IV. Remarks

USSN 09/544683

FIG 1 (Amended)

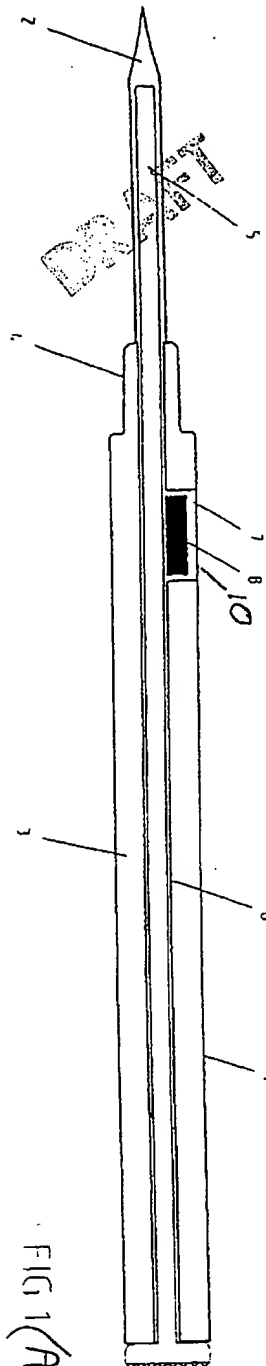
Presently, the drawings are objected to because the Examiner contends they do not show each and every feature of the claimed invention. Applicants respectfully request reconsideration in light of the Disclosure.

The Examiner contends that the phrase “indirectly or directly open connection to the channel and is closed from the outside after preloading” is not shown in the drawings. However, reference to page 5, line 11-26 of the specification clearly shows that Applicants’ disclosure is sufficient. The specification states that the “closing off and opening up of the chamber can be by simple displacement of the plunger ... a door which automatically opens upon full withdrawal of the plunger, or any suitable mechanical, electronic or optical means...” Accordingly, the specification describes various embodiments of a structure to close-off the chamber. Furthermore, Figure b1 does show a closed chamber 7 when the plunger 5 is not withdrawn. The figure clearly illustrates an embodiment wherein chamber 7 is closed, the solid line represents a closed chamber 7. Accordingly, Applicants respectfully request reconsideration of the rejection.
